RESPONSE TO REQUEST FOR ADDITIONAL INFORMATION

US-APWR Design Certification

RAI NO.: NO. 1060-7285 REVISION 4
SRP SECTION: 03.07.02 – Seismic System Analysis
APPLICATION SECTION: 3.7.2
DATE OF RAI ISSUE: 11/15/2013

QUESTION NO. 03.07.02-233:

Figure 15 Response in Vertical Direction-New Storage Pit

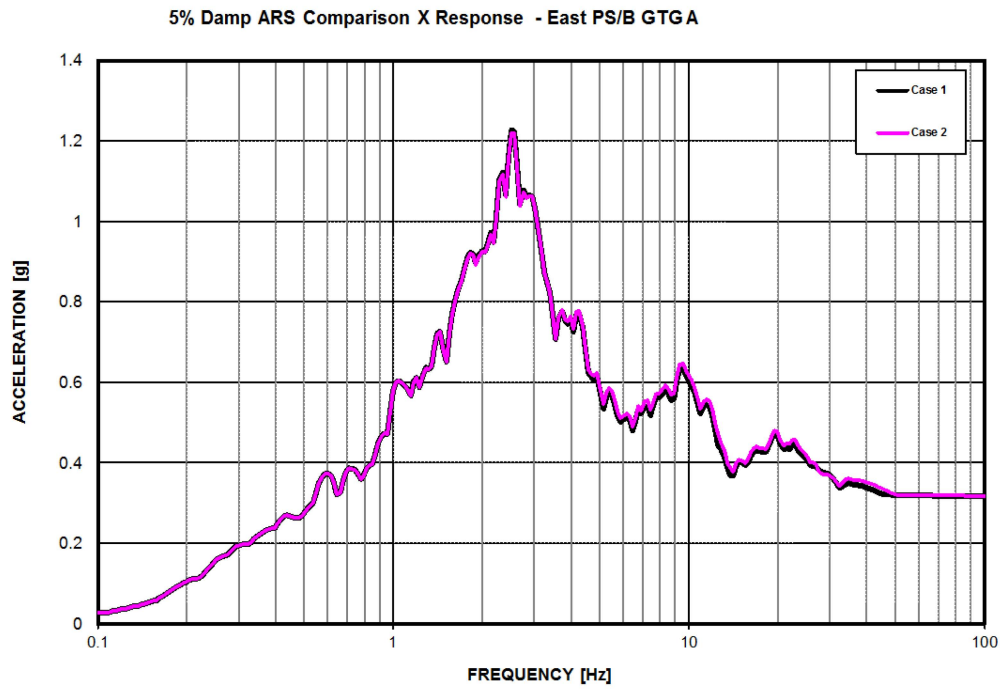
Negligible differences are observed in the horizontal directional responses for the critical locations. This is because the two cases have the same shear wave velocities for the backfill elements. Small differences, with Case 1 responses being higher than Case 2 responses, were observed in the vertical response as shown on Figures 15, 18, and 21 for the New Fuel Storage Pit, GTG A and GTG B, respectively.
